## ARCHITECT'S SUPPLEMENTAL INSTRUCTION NO. 11

**DATE:** July 18, 2024

**RE: Floor Plan Revisions**

**Streets of West Pryor – Lot 13**

**SHEET NUMBER**  
**A-101**

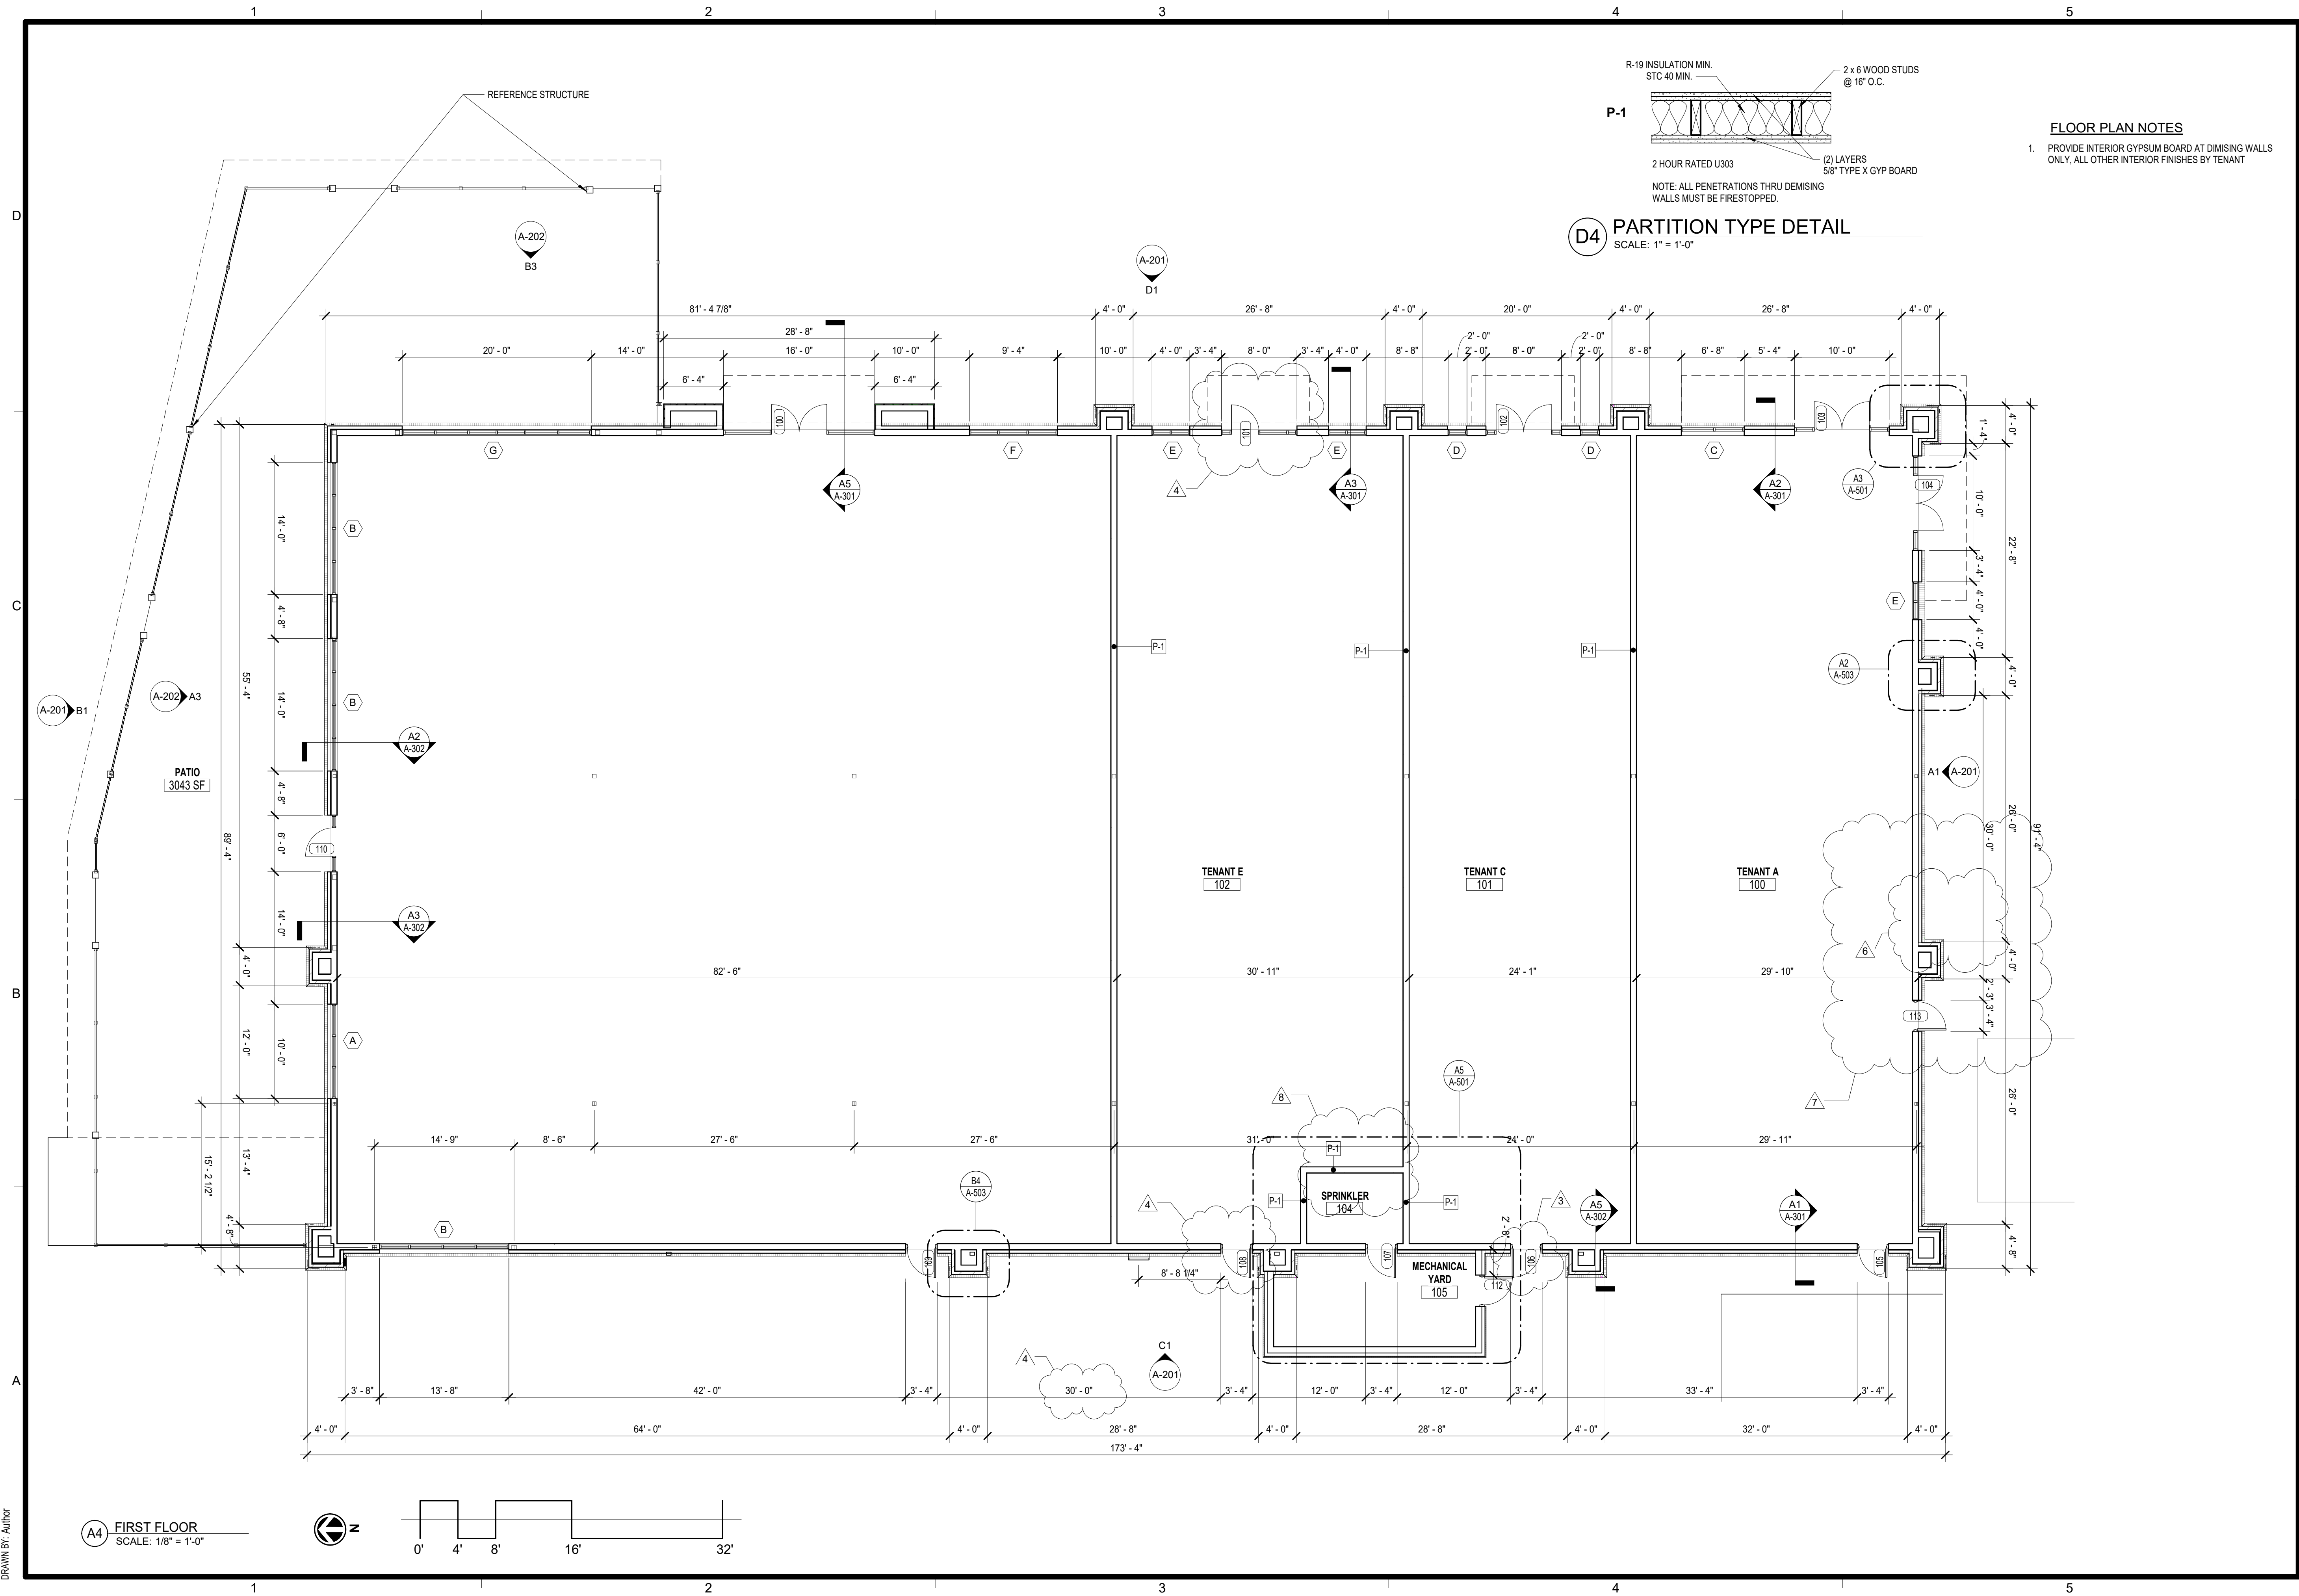
**Item A1: Remove 3'-0" x 7'-0" Hollow metal door (111) from room (104) and project. See attached Architectural sheets**

SHEET NUMBER  
**S-104**

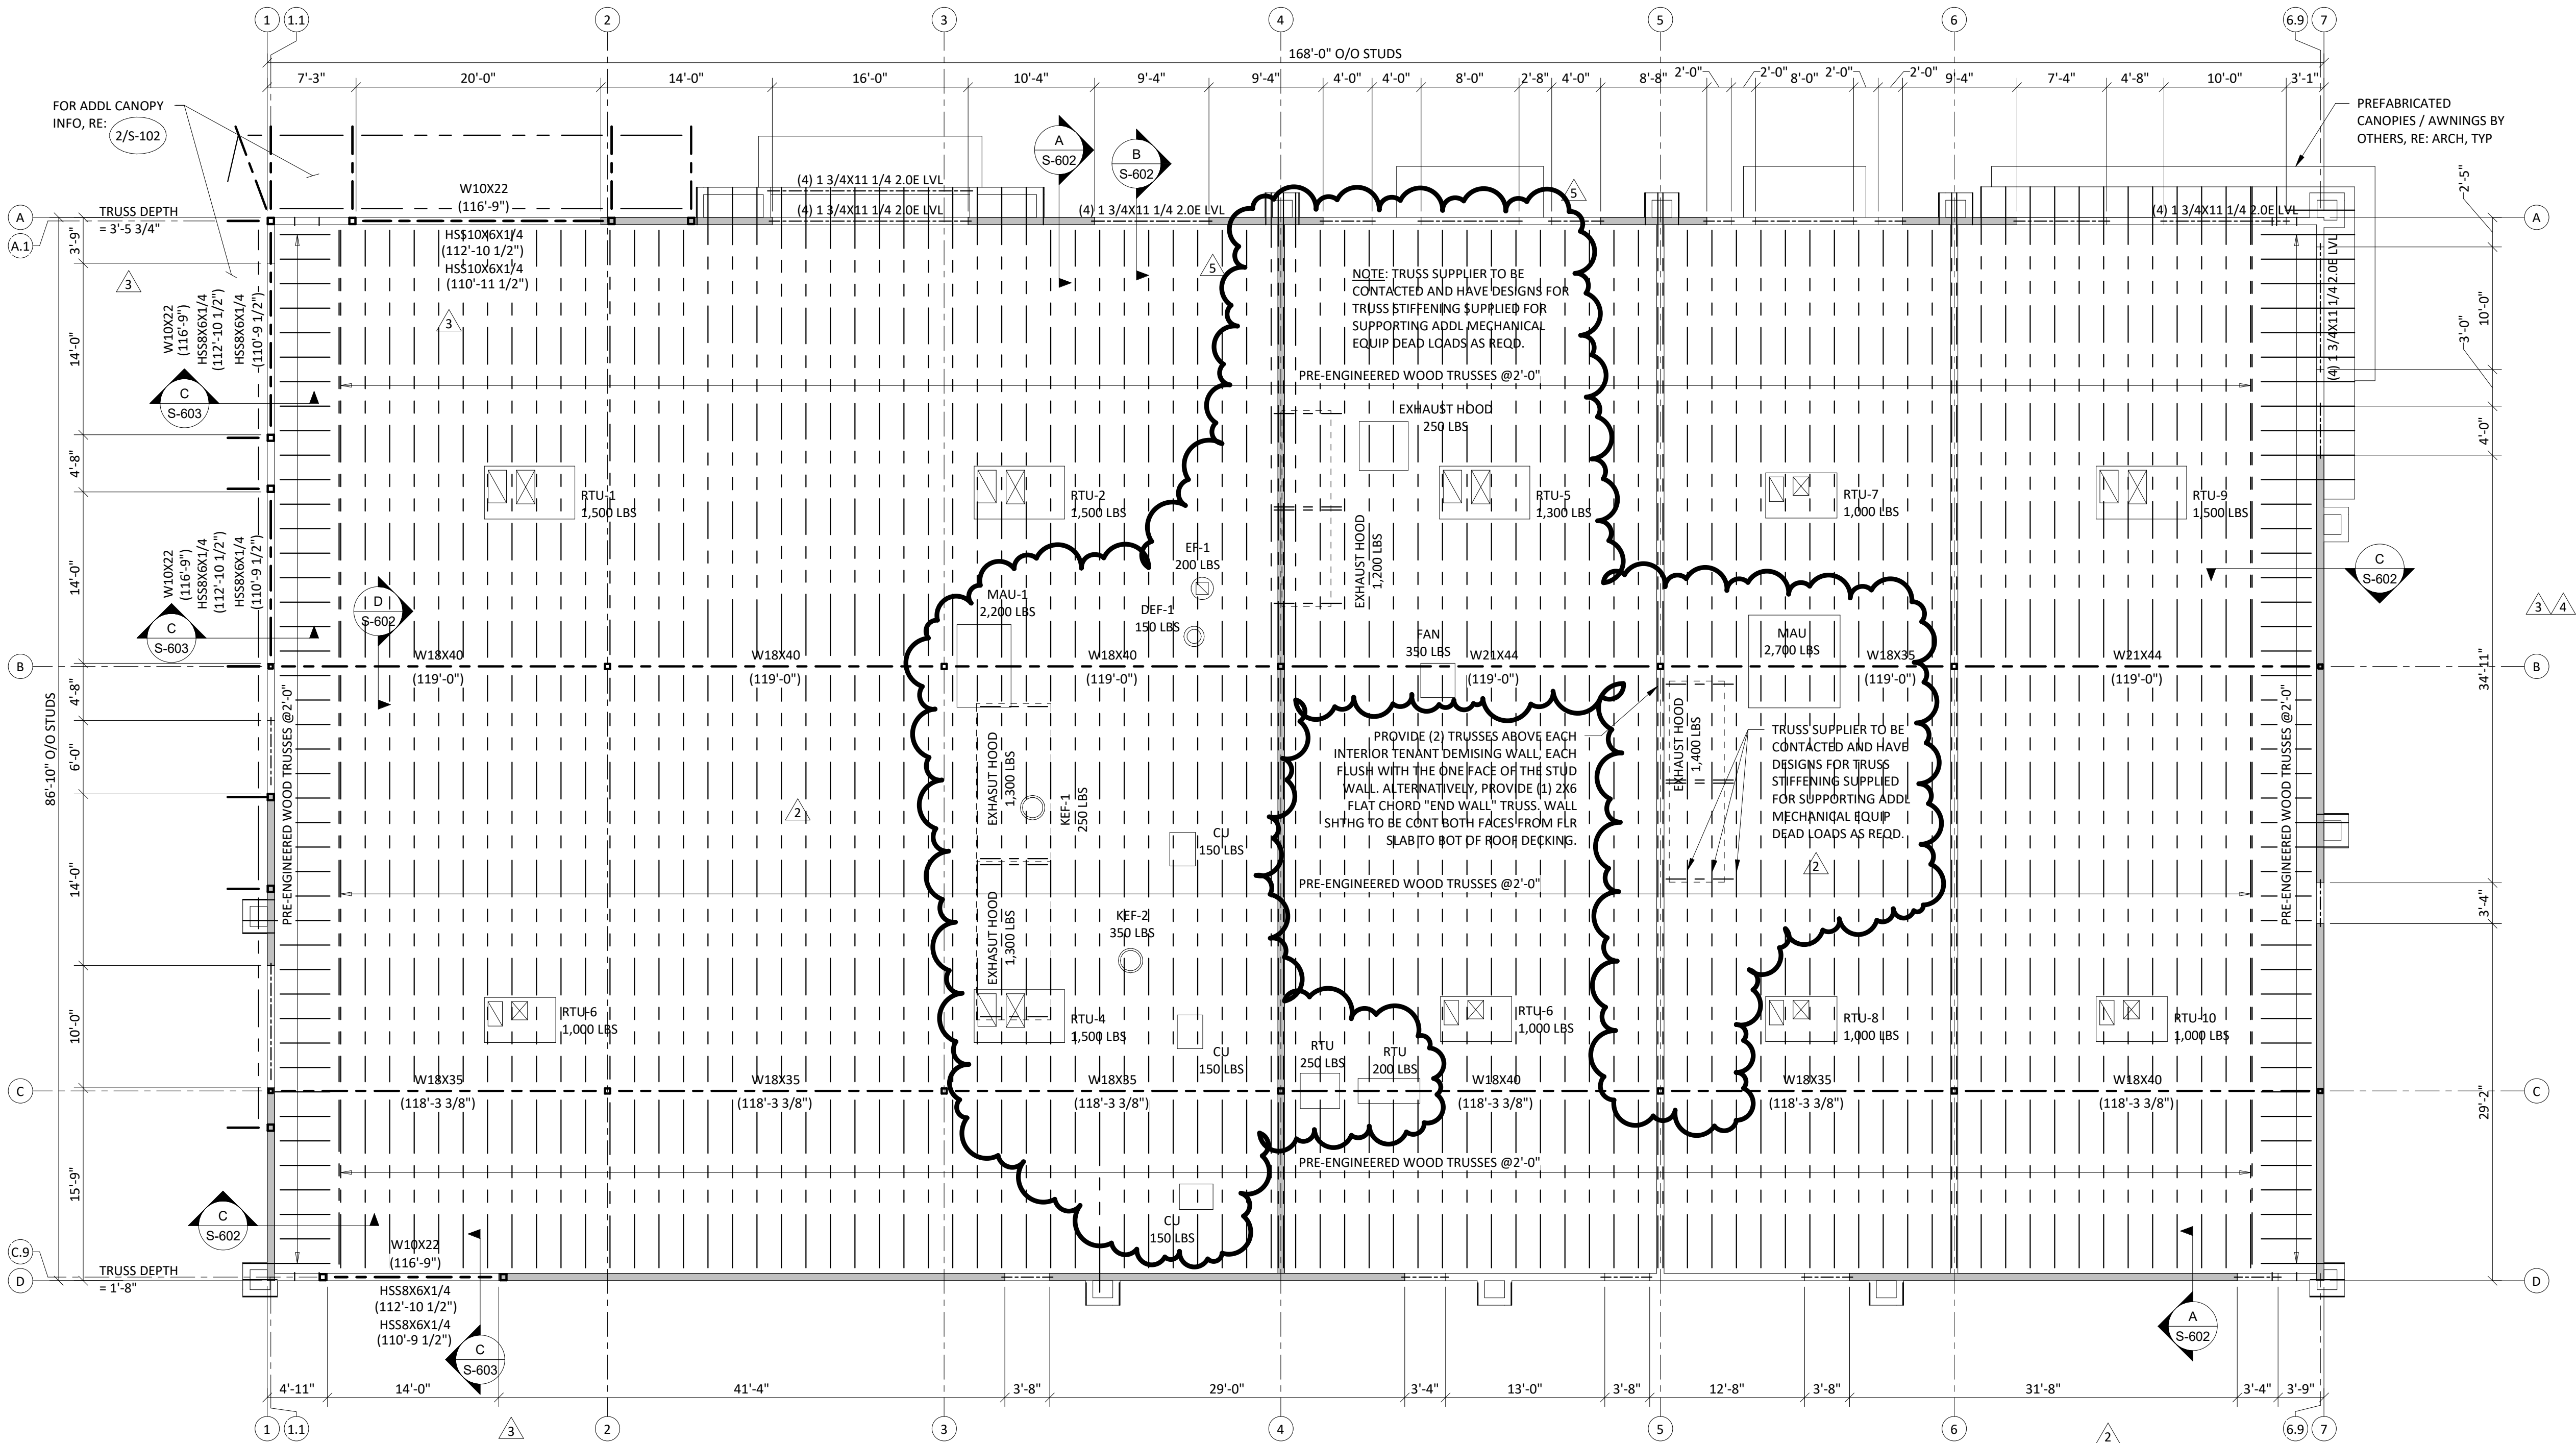
**Item S1: Revisions and additions to the size and location of tenants' rooftop mechanical units. See attached Structural sheet.**

DESIGN ROOF TRUSSES TO SUPPORT RTU LOADS AT LOCATIONS SHOWN. NOTIFY ENGINEER IF WEIGHTS, SIZES, OR LOCATIONS VARY FROM THAT SHOWN.
